Part number **ELEC-747** has been superseded. After this replacement, units will no longer be equipped with a charger interlock. The following models/serial ranges need additional electrical connections to use this part.

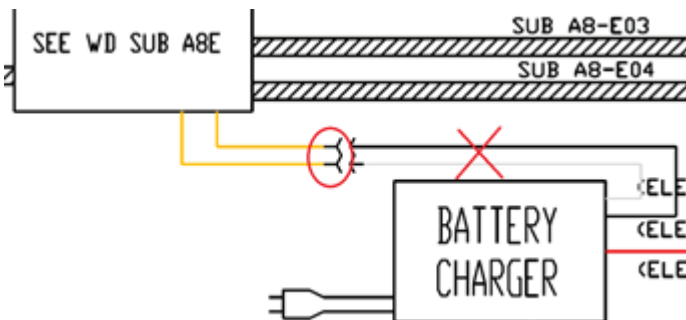
Model HB-1030CE, Serial Numbers E01-10015 to E01-19999; E110001 to E210011; A210012 to A210018

Model HB-1430CE, Serial Numbers E02-10014 to E01-19999; E210002 to E210011; A210012 to A210018

Instead of removing the charger wires, leave them connected to the 7 amp fuse (B+) and the key switch, cut them and butt splice them together.

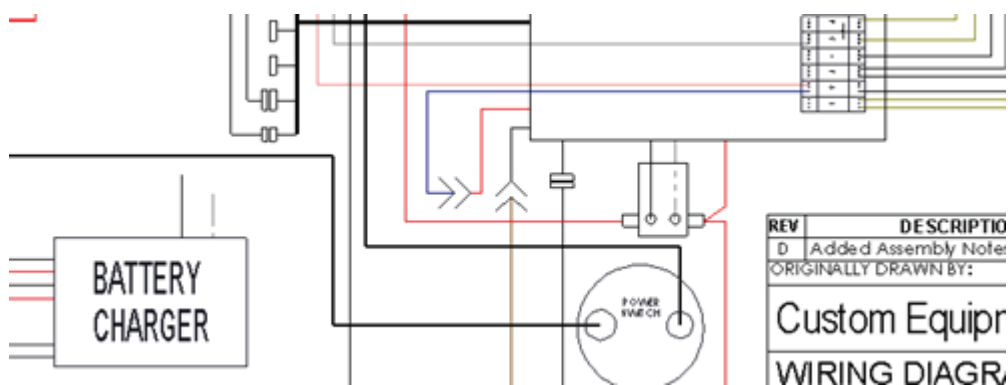
Model HB-1230, Serial Number D08-10000 to D08-19999

Take the black wire from the charger interlock out of terminal block #2. Cut and strip the old charger white interlock wire and install into terminal block #2.

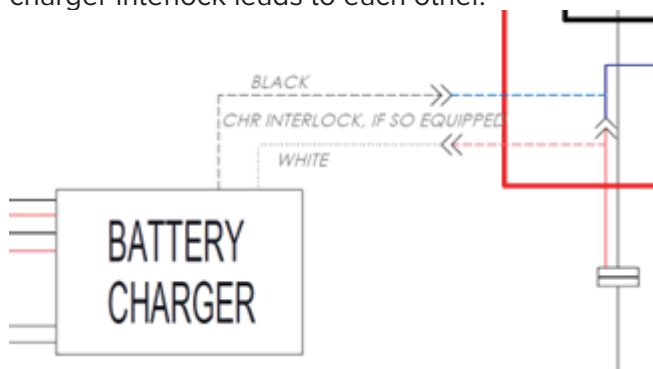
Model HB-1230, Serial Number D08-20040 to D08-30753

Model HB-1230CE, Serial Number E08-25001 to E08-35001

Cut off the male connector on the red wire and replace with a female connector (ELEC-674). Connect the two charger interlock leads to each other.
